Access Compliance Report

Public Rights-of-Way

Intersection ID: 29716	Main Street: GATESVILLE_LN	Cross Street: MEDOC_MOUNTAIN_DR	Location: W
ADA ID: 352CCCBE9E8F	Ramp Type: BlendTrans1	Initial Pass/Fail: Pass	Overall Compliance: No
			Severity Score: 10.25

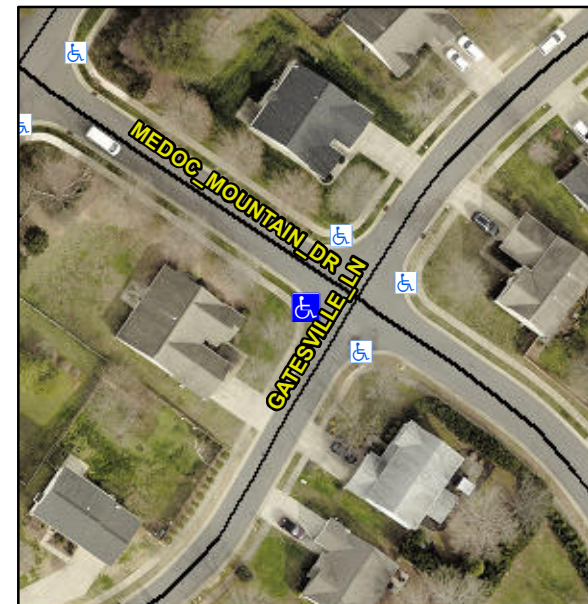
R304.5.3, R304.2.2-Perp, R304.3.2-Para, R305

Compliance	Description	Data	Compliance	Description	Data
N/A	Ramp Length (in)	49.0	Yes	BlendTrans Slope (%)	2.5
Yes	Ramp Width (in)	56.0	No	BlendTrans XSlope (%)	2.6
N/A	Flare Type LT	Sloped	N/A	Flare Type RT	Sloped
N/A	Flare Slope LT (%)	4.0	N/A	Flare Slope RT (%)	1.6
N/A	Flare Traversable LT?	No	N/A	Flare Traversable RT?	No
Yes	Landing Length (in)	48.0	No	DWS Provided?	No
Yes	Landing Width (in)	56.0	N/A	DWS Contrast?	No
No	Landing Slope (%)	2.1	N/A	DWS Length (in)	N/A
Yes	Landing X Slope (%)	0.5	N/A	DWS Full Width?	No
N/A	Landing Curb? (Y/N)	No	N/A	DWS Offset (in)	N/A
N/A	Shared Landing?	No			
Yes	Gutter Ponding?	No	Yes	Gutter Slope (%)	0.5
Yes	Gutter Lip Ht (in)	0.0	Yes	Gutter X Slope (%)	0.4
N/A	Painted X Walk1?	No	N/A	Painted X Walk2?	No
	X Walk 1 Direction	To SE		X Walk 2 Direction	To NE
	X Walk 1 Width (in)	N/A		X Walk 2 Width (in)	N/A
	X Walk 1 Slope (%)	7.1		X Walk 2 Slope (%)	3.9
	X Walk 1 X Slope (%)	6.1		X Walk 2 X Slope (%)	6.3

Remove & Replace Curb Ramp With Two New Directional Ramps or Equivalent.
